ADA Curb Ramp New Construction Inspection Form (Perpendicular)

Nw 285 ave

24952.54

Nw Shaddon st

PERPENDICULAR RAMP (PR)

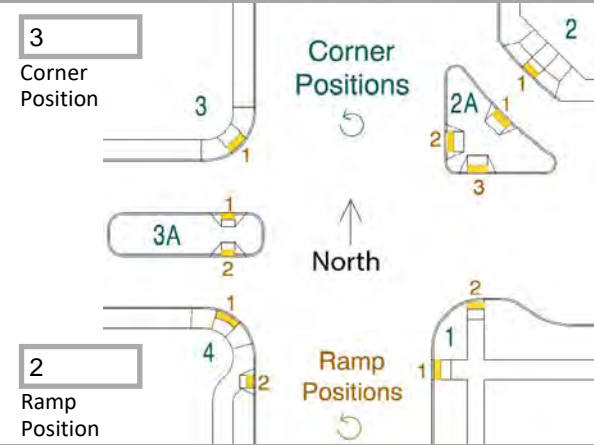
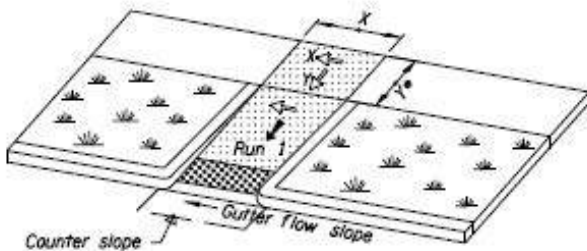
RR 1 ICRR clear width less than 4'
